Simulated ITAAC Closure and Verification Demonstration Project

January 27, 2010

Simulated ITAAC Closure and
Verification Demonstration

Figure 2.2.2-1
Passive Containment Cooling System

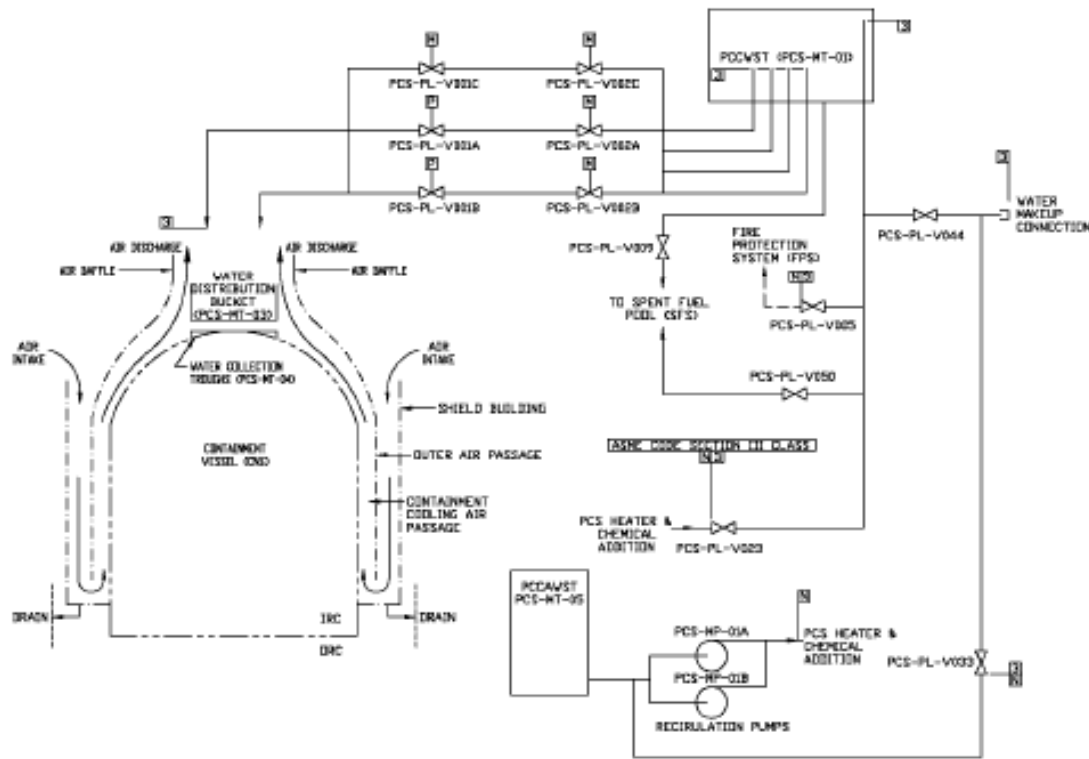
08-01 Example Used:	NRC: D-18 (ABWR Basic Configuration)	SNC: D-1 (Template)
NRC Feedback	SNC/WEC Response	Lesson Learned/ Corrective Action
ICL did not list the walk down procedure in the reference list	Agree (Recurring comment #1)	List as reference
Detailed checklists and observations are not referenced as indicated on D-18 template.	The D-18 example is for an ABWR ITAAC that is not identical to this AP1000 ITAAC, so the wording of the determination basis may not be identical. The walkdown inspection report should be listed as a reference	List inspection report as reference. Discuss/Understand that NEI 08-01 Appendix D letters are <i>examples</i> that are useful comparisons, but may not yield verbatim compliance.
The referenced table and figure in the IDB did not list or show all the sensors and valves as required in the acceptance criteria	The referenced table and figure are from Tier 1 of the certified design, and they provide the complete basis for meeting the acceptance criteria. “All the sensors and valves” are not part of Tier 1, and therefore not part of this ITAAC.	Discuss during public meeting

The IDB did not indicate that each component is in its proper functional or logical (for I&C) relation to the system	The IDB wording can be improved, however most of the ABWR “basic configuration” in D-18 is handled by other AP1000 ITAAC.	Discuss during public meeting
